WLD5 - Replacing Hose for Positive Crankcase Ventilation (Workshop Campaign)

Model Line: **Panamera (971)**

Subject: **Positive crankcase ventilation hose**

Installation location for positive crankcase ventilation hose.

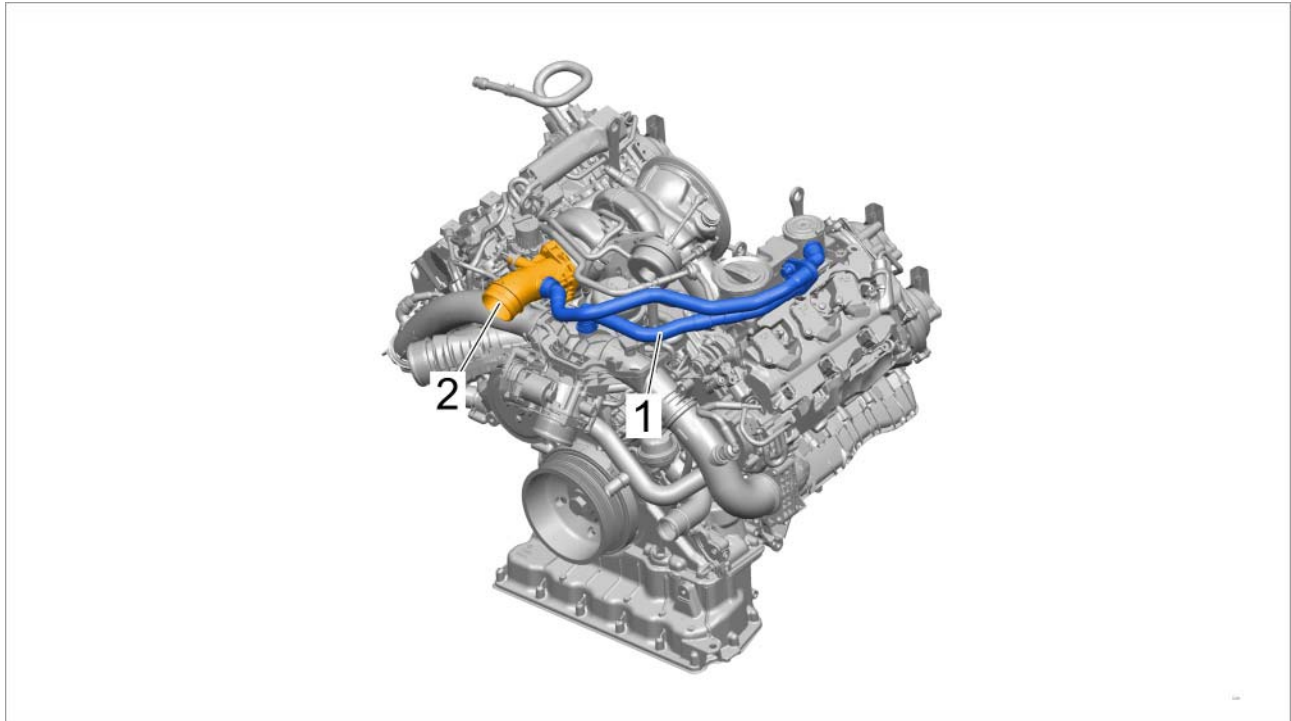
Information: **A part-load valve was installed in the hose for crankcase ventilation on the affected vehicles which has a sealing washer that does not meet the required specifications and could possibly crack when the crankcase pressure rises.**

Consequently, small amounts of engine oil can leak from the oil filler cover into the adjacent engine compartment, resulting in a reduced engine oil level over time. The driver is alerted by an appropriate warning message if the engine oil level is too low.

Remedial Action: Replace positive crankcase ventilation hose with intake manifold.

Installation location for positive crankcase ventilation hose.

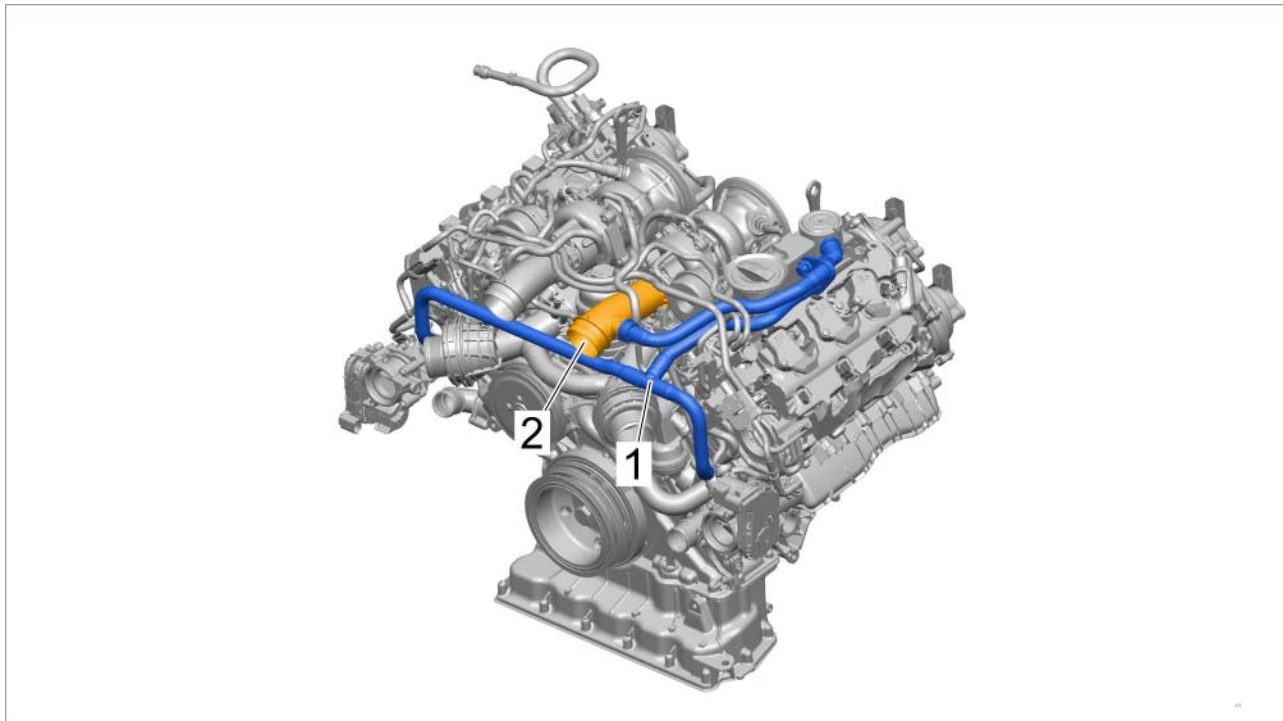
Information: **A part-load valve was installed in the hose for crankcase ventilation on the affected vehicles which has a sealing washer that does not meet the required specifications and could possibly crack when the crankcase pressure rises.**

Consequently, small amounts of engine oil can leak from the oil filler cover into the adjacent engine compartment, resulting in a reduced engine oil level over time. The driver is alerted by an appropriate warning message if the engine oil level is too low.

Remedial Action: Replace positive crankcase ventilation hose with intake manifold.
